# Technical Service Bulletin

**MODEL(S) AFFECTED:** **T500/T500e Walk-behind Scrubber**

**SUBJECT:** Solution filter bowl ground clearance.

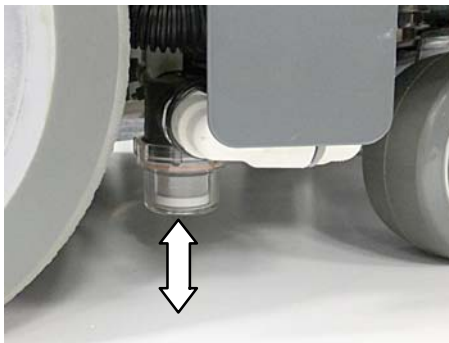
For models manufactured after the above dates, the machine frame was modified to allow the filter bowl to be orientated horizontally toward the rear of machine as shown below. This provides convenient access for filter bowl removal. A yellow maintenance touch point label was also added.

Solution filter bowl ground clearance on existing machines.

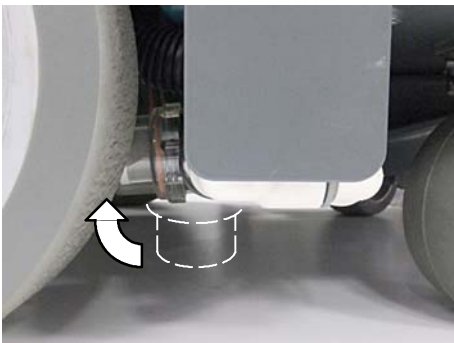
To increase ground clearance, simply rotate the filter bowl 90 degrees toward the front of the machine as shown. Re-secure with cable-ties.
